Site: Presbyterian - 6400 Paseo Del Norte NE

Re: Drainage Ordinance (14-5-2-1) Violations for Erosion and Sediment Control and Construction Site Waste

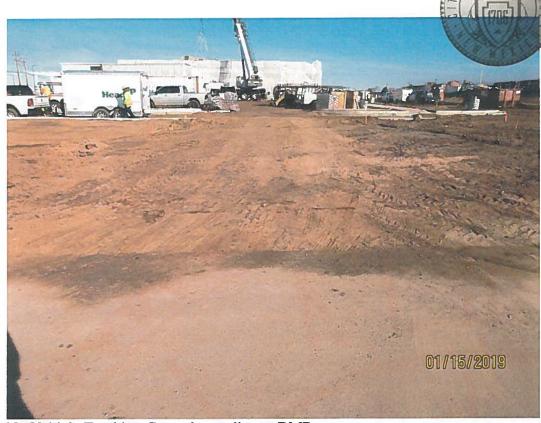
Sediment in street and dirt ramp in street/gutter.

No Vehicle Tracking Control or sediment BMP.

- 1. Remove sediment from Palomas Ave. fronting your project as well as the curb return/gutter on San Pedro. Vehicles will have to be moved from the north side of Palomas Ave. to remove sediment from the street.
- 2. Remove the dirt ramp from Palomas Ave.

3. Provide Vehicle Tracking Control.

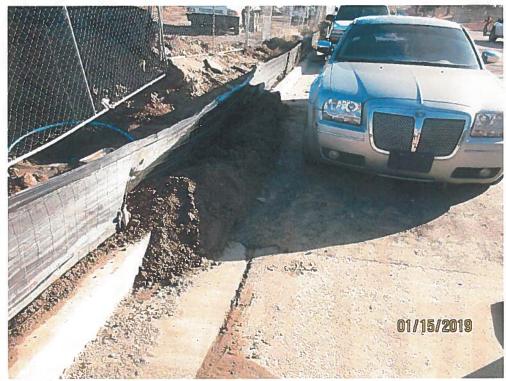
Sediment in Palomas Ave.

Sediment at intersection of Palomas and San Pedro.
